ADDENDUM NO. 02

Oak Hill United School Corporation – Multi-School MEP Improvements
405 South Washington St, Swayzee, IN 46986
7760 Delphi Pike, Converse, IN 46919
600 Walnut St, Converse, IN 46919

ADDENDUM TWO

Addendum Two (AD.02) to the drawings and specifications prepared by Gibraltar Design for **Mechanical Improvements Across Three Schools** for Oak Hill United School Corporation Converse, Indiana.

ED103

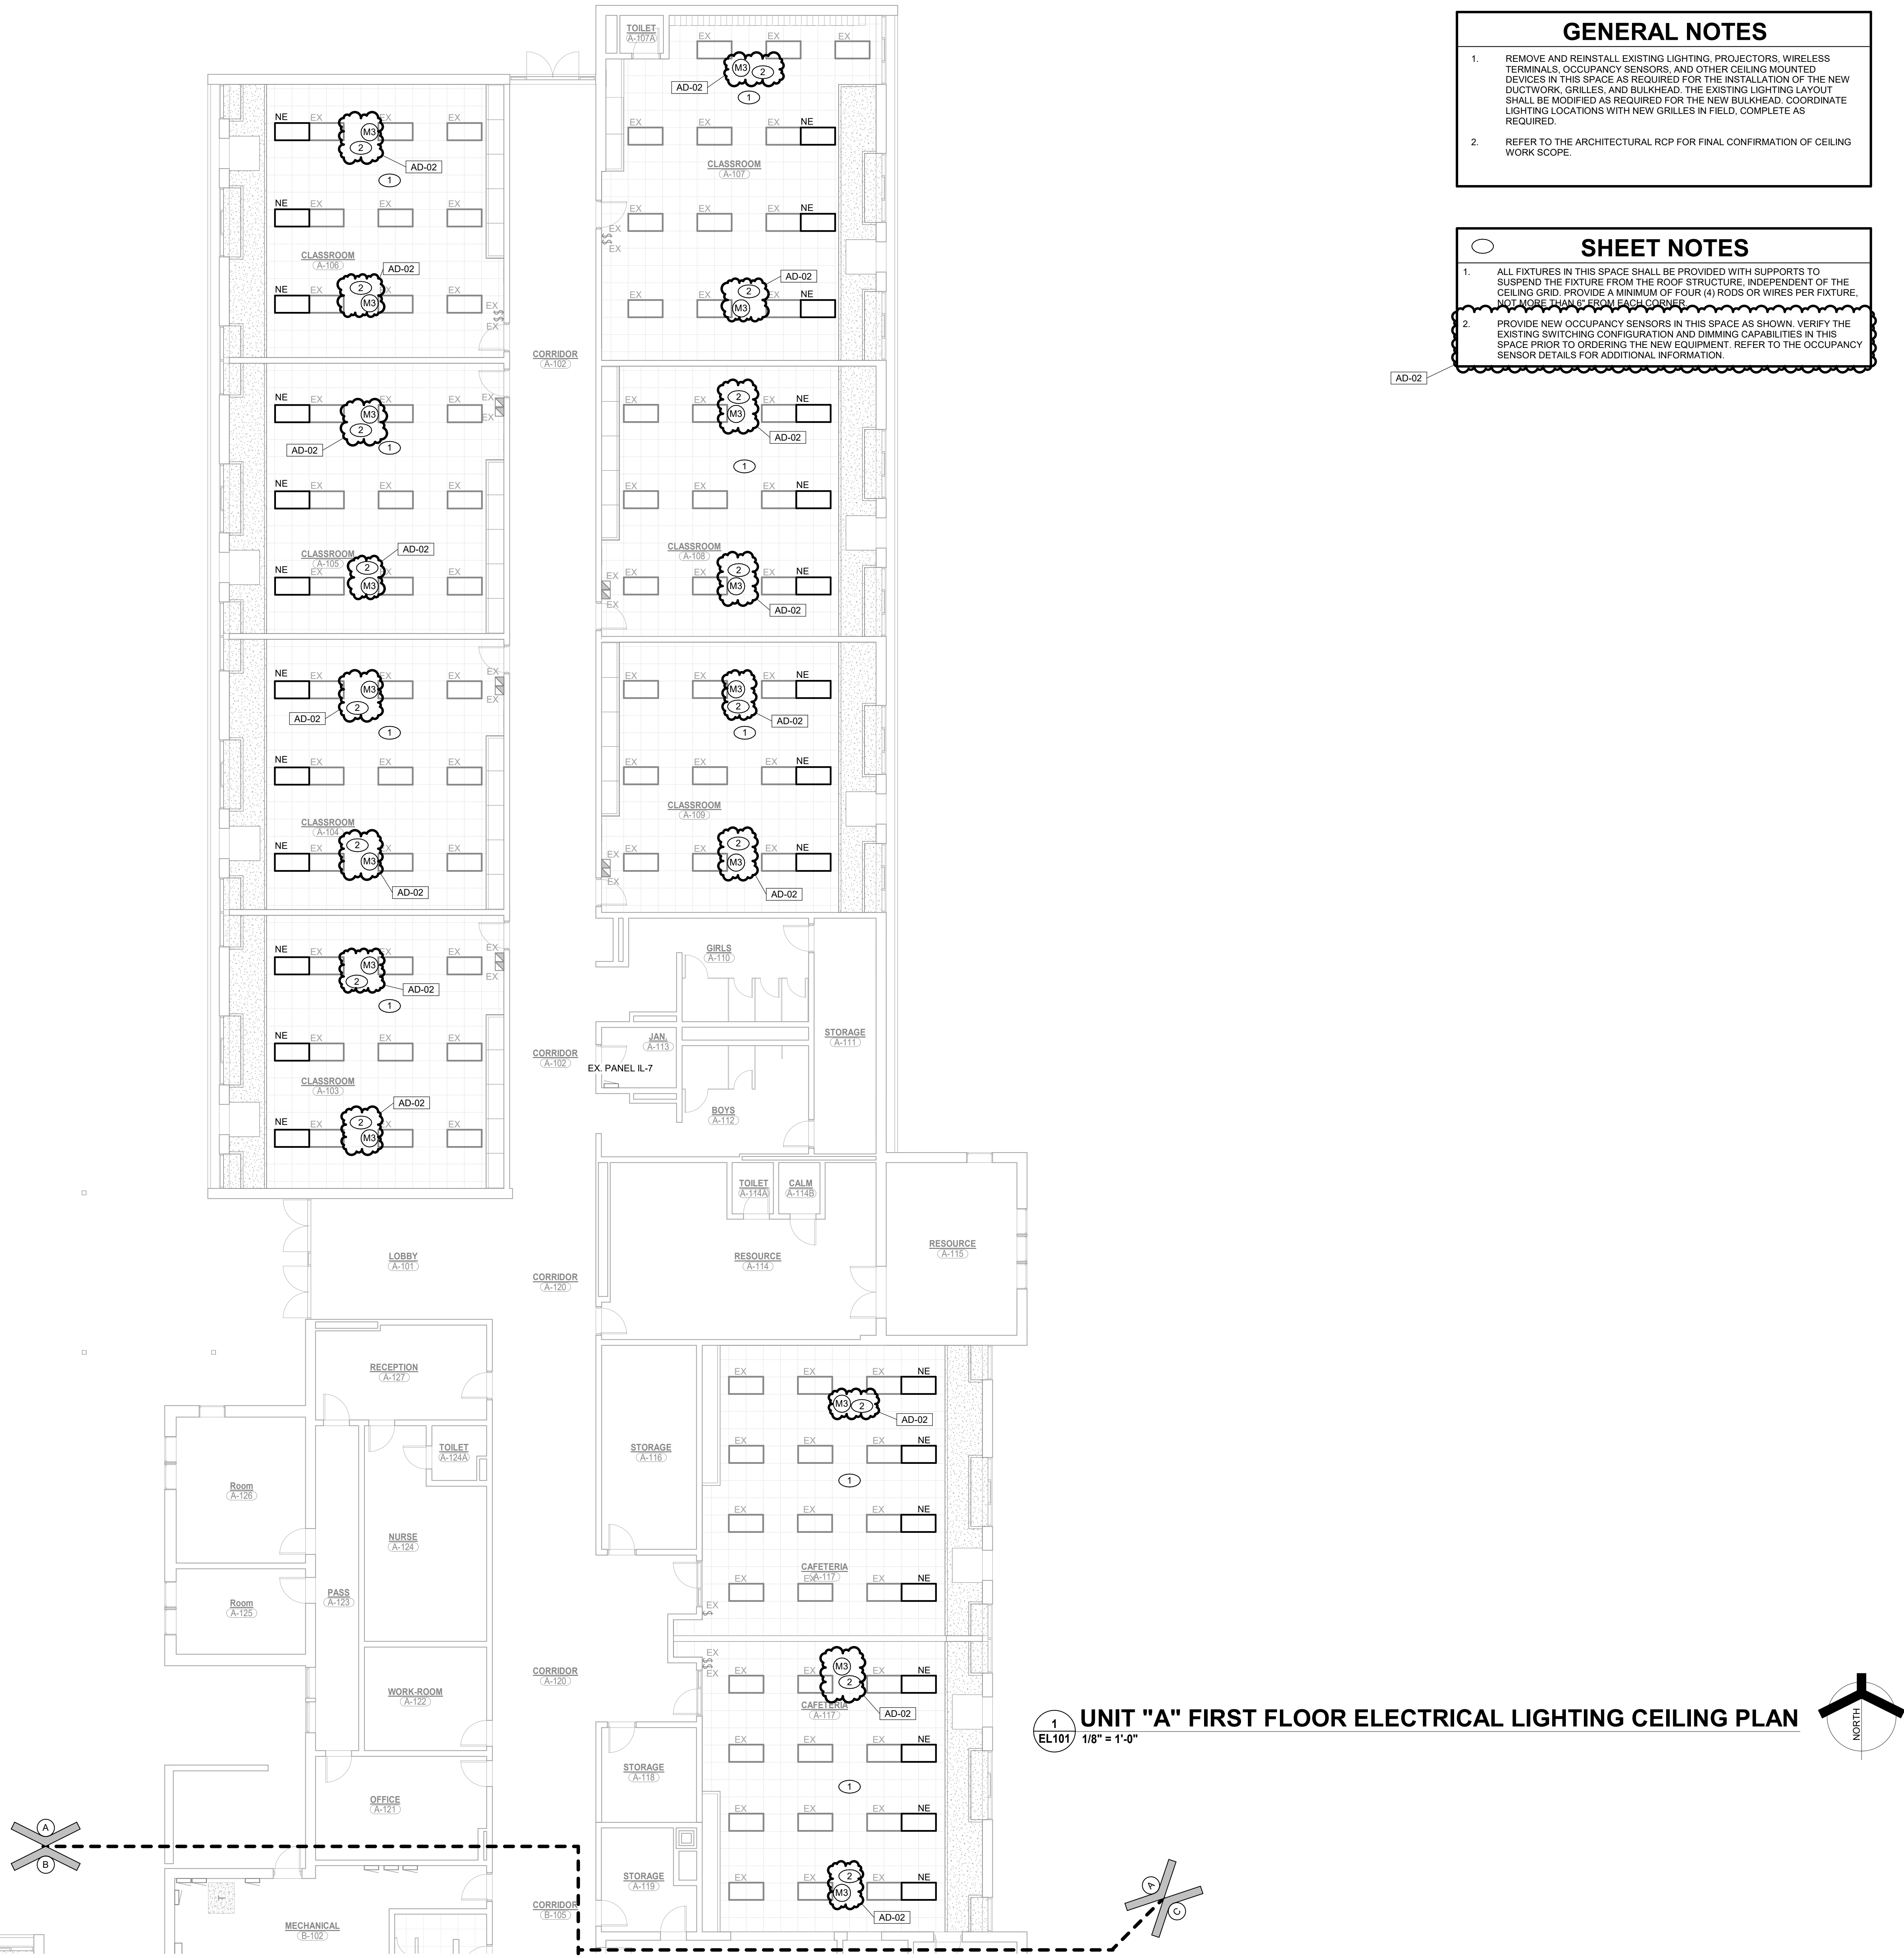
5. Sheet ED103

1. Revised occupancy sensor layout.

1
EL102
UNIT "B" FIRST FLOOR ELECTRICAL LIGHTING CEILING PLAN
1/8" = 1'-0"

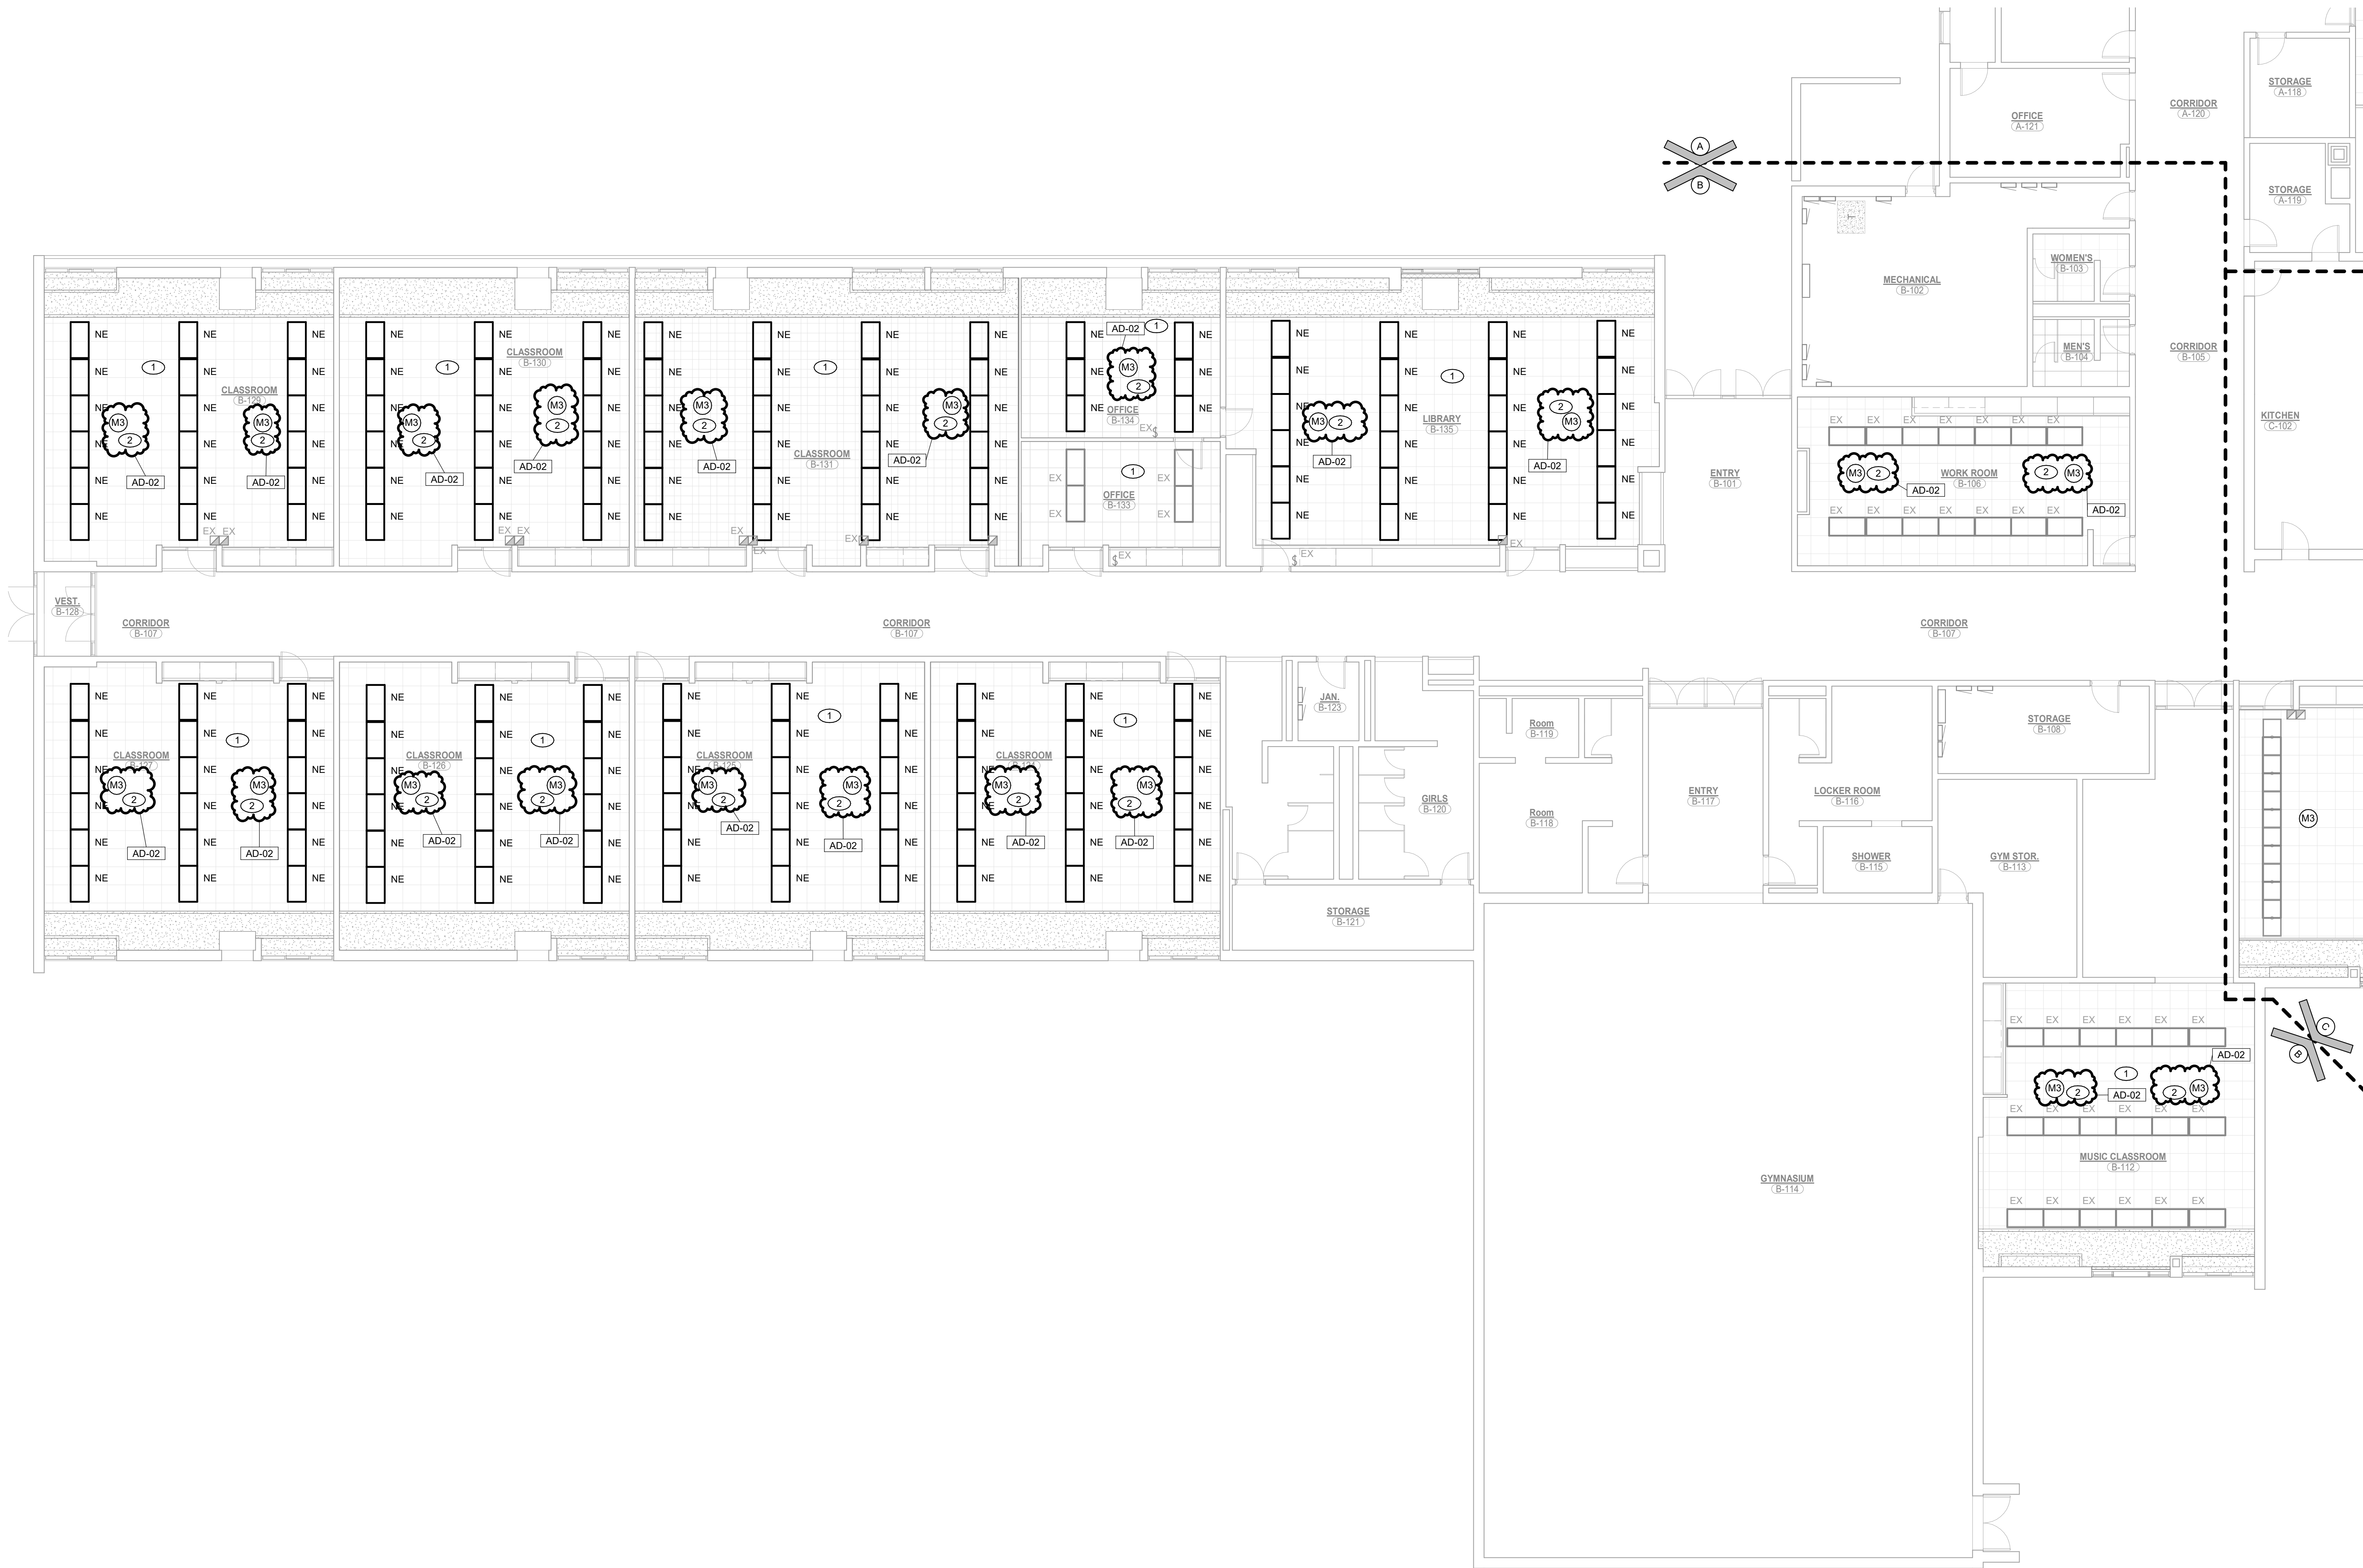
7. Sheet EL102

- A. Refer to revised, full-size drawing, included in this Addendum, for revisions.
 - 1. Added Sheet Note #2.
 - 2. Added and revised occupancy sensors and occupancy sensor layout.
